Subject: Independent Review of Westside Subway Extension Century City Reports

Preliminary Review Comments
of Century City Area
Fault Investigation Report
Westside Subway Extension Project
Century City and Beverly Hills, CA

March 8, 2012

51-1-10024-003

Map adapted from Fault Exploration Plan Century City Area, by AMEC, 10-14-2011 .

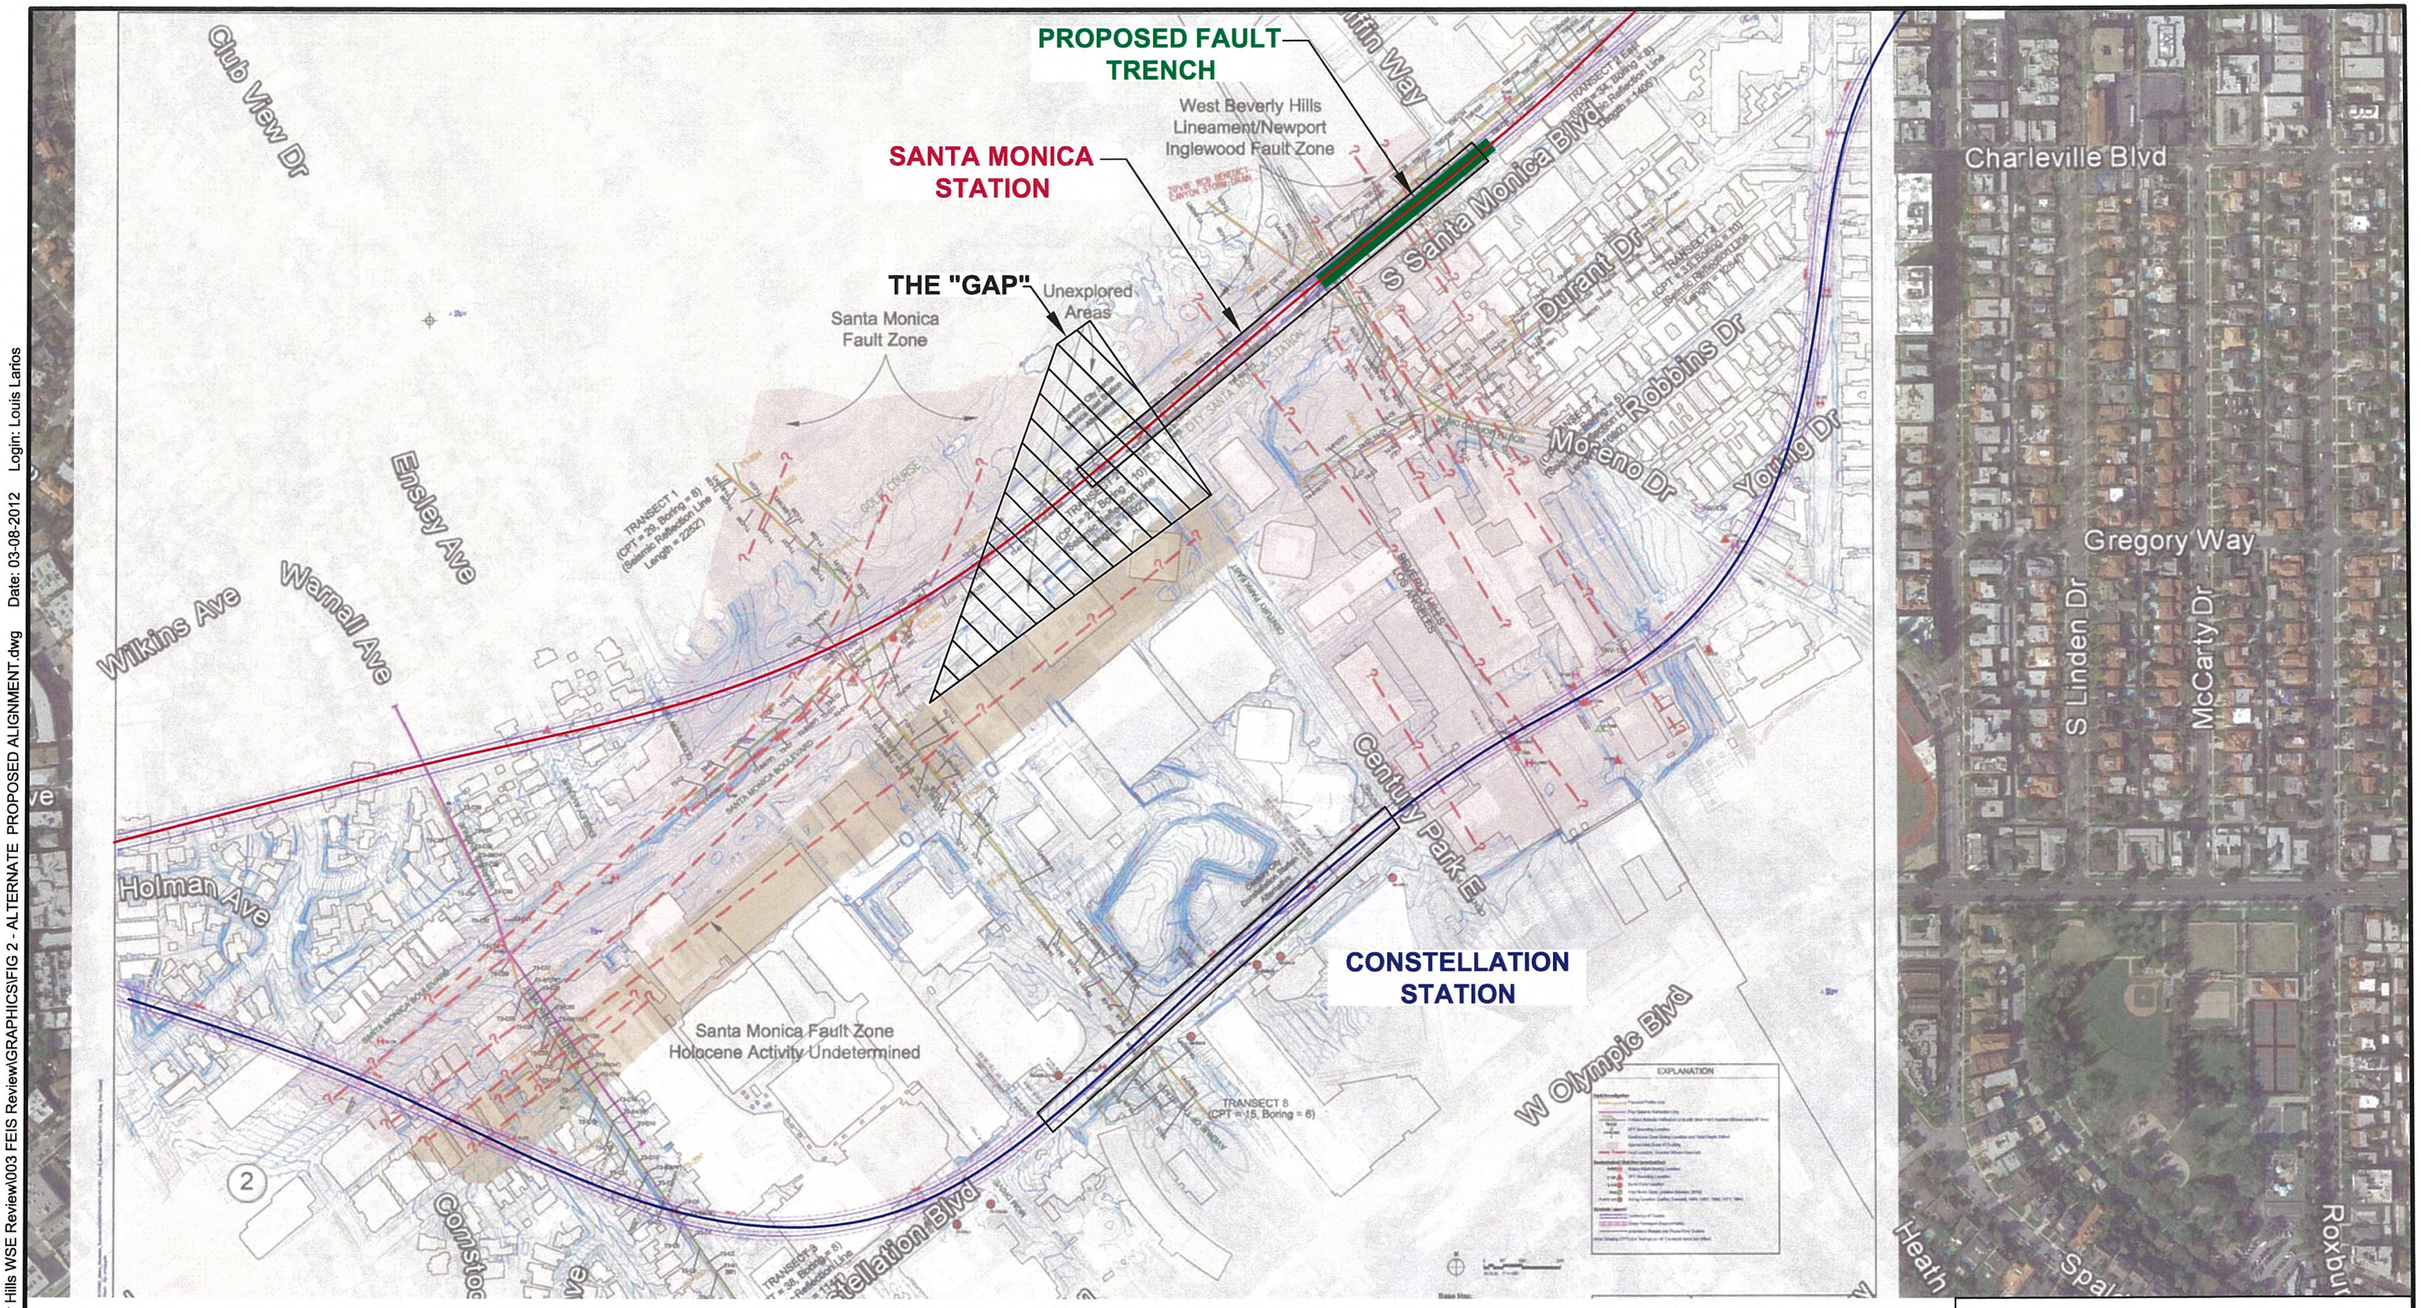
Santa Monica Station Relocation – Relocating the station further south or east along Santa Monica Boulevard, including the gap (see Figure 2) between the Santa Monica Fault Zone (SMFZ) and West Beverly Hills Lineament/Newport Inglewood Fault Zone (WBHL), has risks similar to the current proposed Santa Monica Station owing to high probability of ground deformation stemming from earthquakes originating from the SMFZ or by previously unmapped fault splays. Data collected at the recent fault trenching performed at BHHS, does not appear to indicate that the WBHL is an active fault. Relocating the Santa Monica Station further east as shown in Figure 2 could be feasible if the WBHL is also shown to be inactive where it crosses Santa Monica Boulevard, and if the SMFZ terminates west of the Beverly Hills City Limits. We recommended fault trenching occur at the station location.

As shown in Figure 2, traces of the SMFZ are interpreted to curve northeast near the intersection with the WBHL, leaving a gap between the two faults along Santa Monica Boulevard. However, the apparent curves of the fault traces may be due to topographic

variations and could be misleading. Also, fault rupture is not the only potential issue associated with displacement of the SMFZ. Ground deformation due to complex fault movements could increase stresses on the buried walls at the station. However, based on the recent BHHS trench investigations, the WBHL may not be present or active in this area. Consequently additional studies may be warranted to assess if moving the station into this apparent "gap", or even further to the east, is a viable alternative.

It is uncertain if the main trace of the SMFZ, or a fault splay, lies within the gap, even though maps presented in the Fault Report indicate otherwise. The Fault Report notes that the portion of the SMFZ that bends away from Santa Monica Boulevard is within an area that may have been modified by stream activity. The erosion could have modified the topographic expression of the SMFZ to make it appear that the fault curves to the north, when in actuality it could follow Santa Monica Boulevard in a more straight-line fashion until it intersects with the WBHL. As a result, there is a reasonable chance that the SMFZ crosses the gap.

As discussed above, we recommend that additional studies be considered to determine fault activity of the WBHL in the vicinity of Santa Monica Boulevard. An east-west fault trench could be excavated in the old railroad right-of-way on the south side of "Big" Santa Monica Boulevard as shown in Figure 2 and Photograph 1 below, to confirm the WBHL findings at the BHHS. A north-south fault trench perpendicular to the trace of the SMFZ should also be considered at the west end of the proposed station in this area to confirm the termination of the SMFZ at the WBHL. Depending on the results of these additional studies, locating the station within the currently denoted WBHL may be feasible.
